Chair Roger Heeringa  
BFRW Committee  
State Building Code Council  
PO Box 41449  
Olympia, WA 98504

RE: WSAFM Emergency Petition for IFC 504

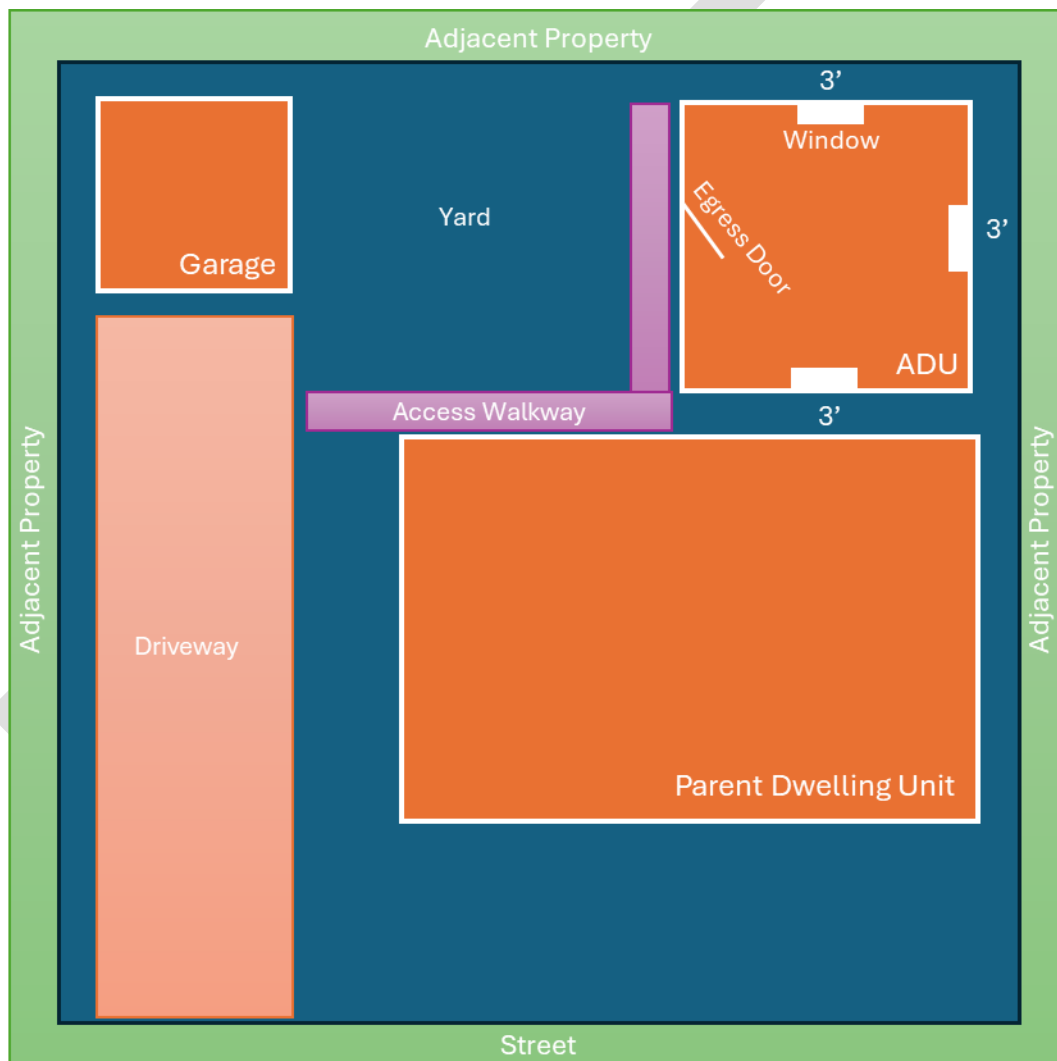
Below is a rough diagram to visualize a potential instance of where this section may apply.

**504.1.1 ~~Width~~ Required access for residential dwelling units.** ~~For jurisdictions that do not specify a minimum width, a minimum of 5 feet clear width is required for access to building entrances that~~ New dwelling units built under the International Residential Code shall be provided with an *approved* access walkway leading from fire apparatus access roads to the exterior egress door required by R311.1, where the exterior egress door does not face the street, alley, a public way or parking lot. The access walkway shall have a minimum 4-foot clear width.

- ~~1. Buildings provided with an approved automatic fire sprinkler system can be reduced to a 4 foot clear width.~~
2. The fire code official or local authority having jurisdiction does not require an *approved* access walkway or requires a minimum clear width less than 4 feet.
3. Shared access ~~path~~walkways between buildings on adjacent lots with a minimum 4-foot clear width shall meet the requirements of this section.
4. Where the building is one story above grade plane.
